Davis Field

Town of Sudbury ADA Transition Plan

December 2020

Institute for Human Centered Design

Unpaved Parking Lots

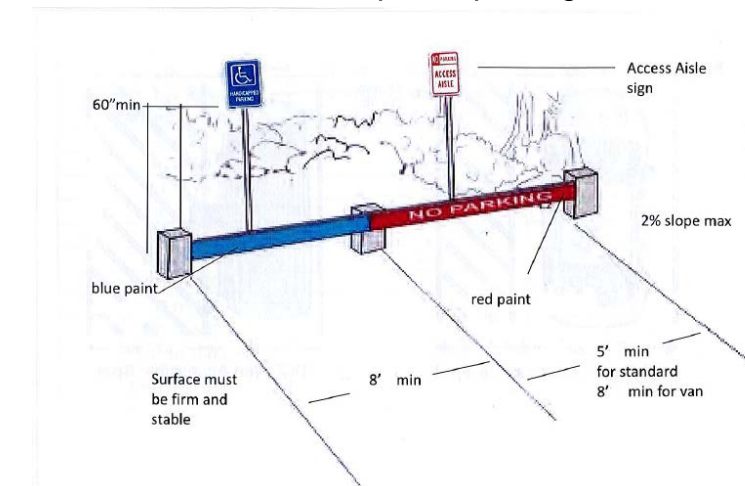
- The following image is based on the Massachusetts Department of Conservation and Recreation (DCR) Pocket Guide. It shows a suggested method of designating an access aisle in an unpaved parking lot.

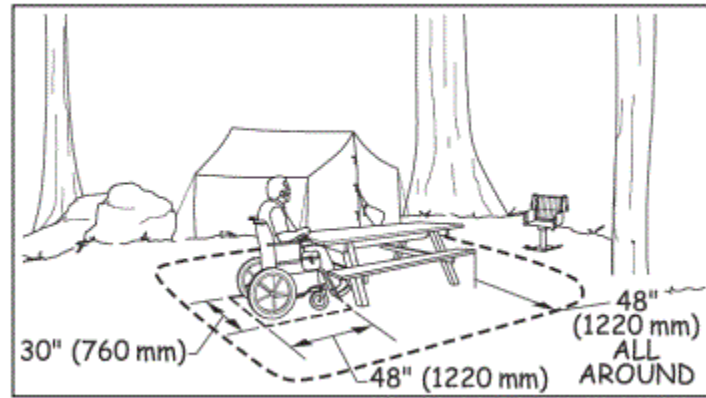
- Recommend providing a 48" wide min. stable, firm and slip resistant surface under and around an accessible picnic table once it is connected to an accessible route. See the following image:

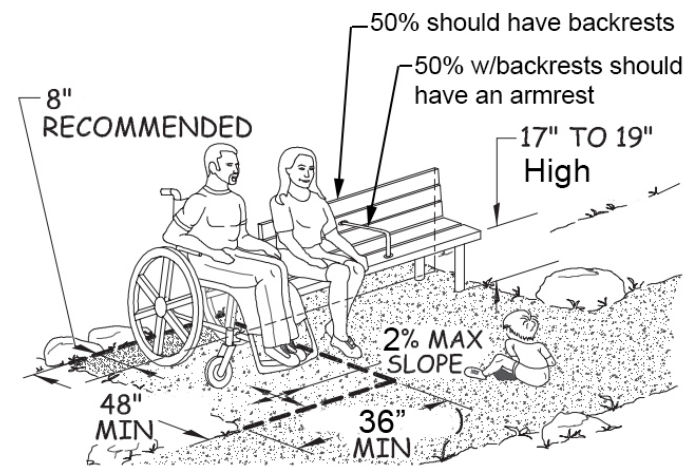
- Recommend providing clear floor space of 36" wide minimum by 48" deep alongside one bench so that a wheelchair user can sit alongside someone sitting on the bench. See the following diagram:
